SUBJECT: 007999 – SR99 Bored Tunnel Alternative Design-Build Project
Federal-Aid No. BR-NH-STP-STPF-0099(111)
CO# 088 – S. Portal 26kV Vista Switch Rev

Attached for HQ review and execution is Change Order No. 088 "S. Portal 26kV Vista Switch Rev".

Notice of Design Change

RFC Package, Title: South Operations Building - Mechanical
RFC Package, Original Doc Control Number: H-D-PAK-SOB-TR2.34-00362-04-RFC-1211-21
NDC Package Name: S. Ops Service Revisions
NDC Package Doc Control Number: H-D-PAK-SOB-TR2.34-00362-10-NDC-1303-11

NDC060 - UTL-E100
 POWER & COMM. SERVICE UTILITIES, PLAN & PROFILE

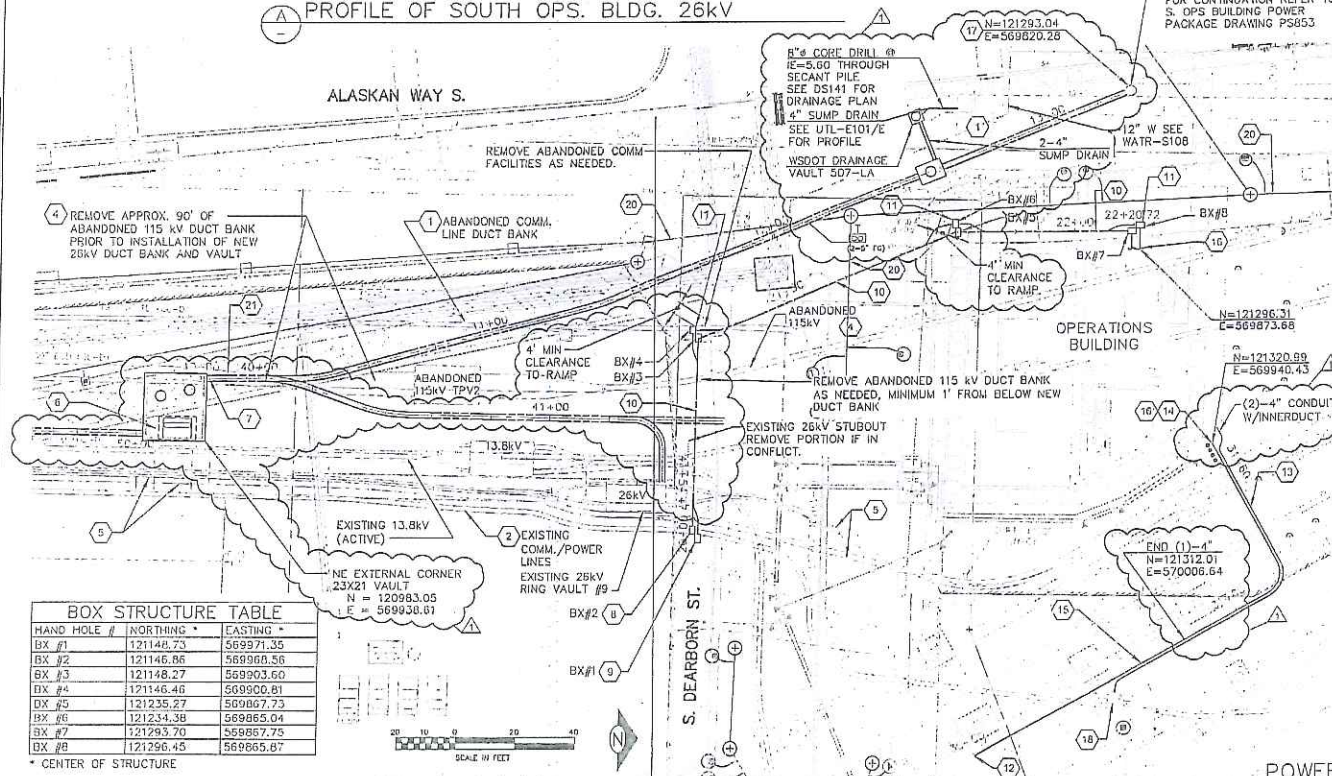
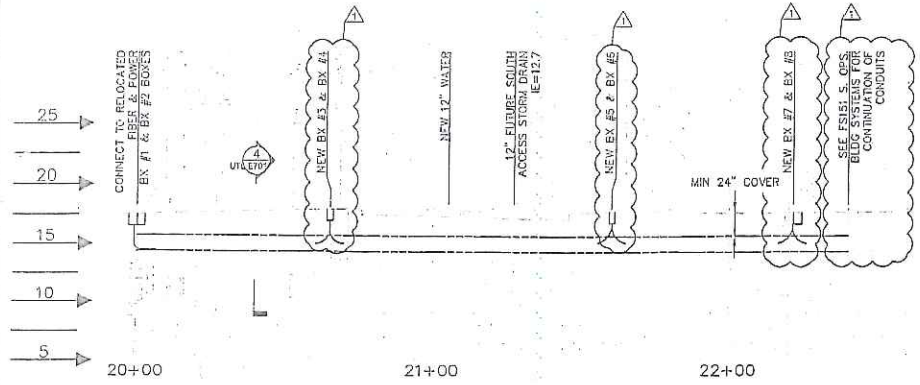
Change profile of power service for S. Ops Bldg. to accommodate temporary UG utilities to TBM;
Add feeder conduit ductbanks into and out of new Vista Vault to existing SCL ring vaults per revised SCL requirements.
Add Vista Vault design plan, elevation and detail, per SCL. This design will be provided by SCL and added to this NDC.

Revised UTL-E100; E701, E701
Add plan, profile, detail sheets for feeder conduit ductbanks between SCL Ring vaults #8 and #9 and new Vista Vault. E702,
Add plan, elevation and detail sheets for new Vista Vault E702, E703, E704, E705, E706, E707
